July 30, 2014 – Architect's
Certification of Market Value
and Substantial Damage

Architect's Certification of Market Value and Substantial Damage

September 2014 – Letter From
Architect Re: Flood Regulation
Compliance

January 30, 2015 – DOB
Resolved Objection 7 (From
January 2014 Objections sheet)

DATE	09/2013
DRAWN BY	JOR
VERIFIED BY	RJP
SCALE	1/8" = 1'-0"
PROJECT NO.	27-2013
SHEET TITLE	West Elevation
SHEET NO.	A007.02
	7 OF 14
CAD FILE	182gir west.dwg

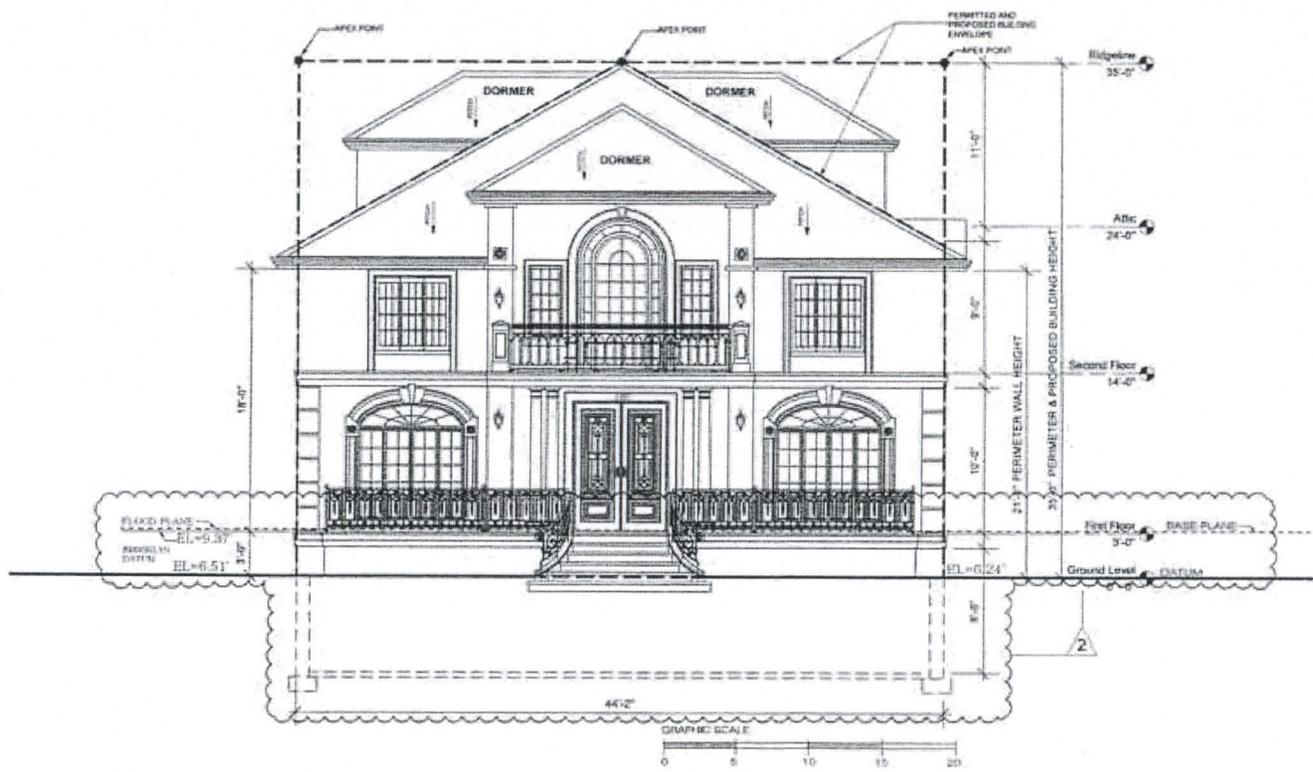
REVISIONS AND SUBMISSIONS	DESCRIPTION	DATE
1	MINOR ALTERATION OF WINDOWS/DOORS	
2	Revised of Blanking by 5'-2"	
3	Minor graphic alteration

DATE	09/2013
DRAWN BY	JOR
VERIFIED BY	RJP
SCALE	1/8" = 1'-0"
PROJECT NO.	27-2013
SHEET TITLE	East Elevation
SHEET NO.	A010.02
	10 of 14
CAD FILE	182girard.dwg

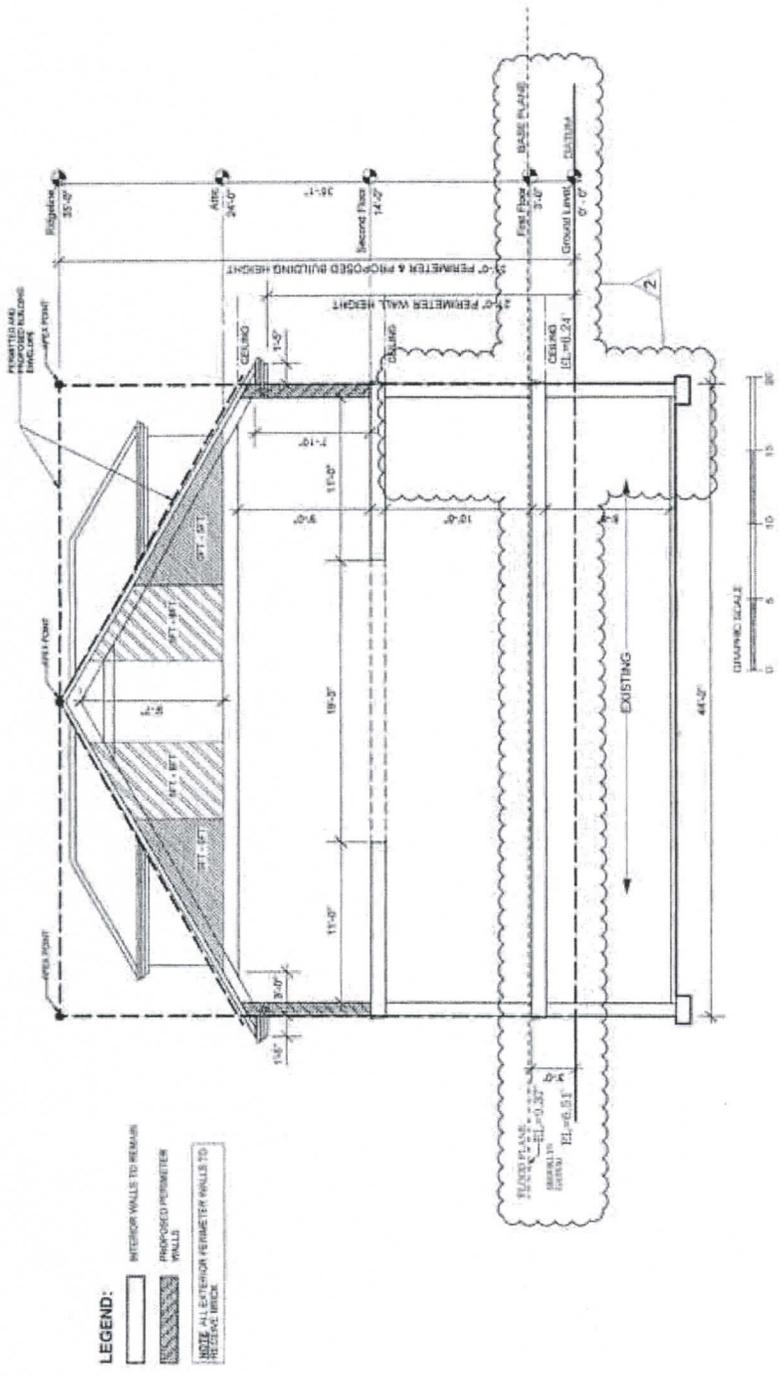
REVISIONS AND SUBMISSIONS	DESCRIPTION
1	MINOR EXTERIOR ALTERATIONS Raising of Blanking by 5'-2" Minor graphic alteration
BY JOR	
DATE
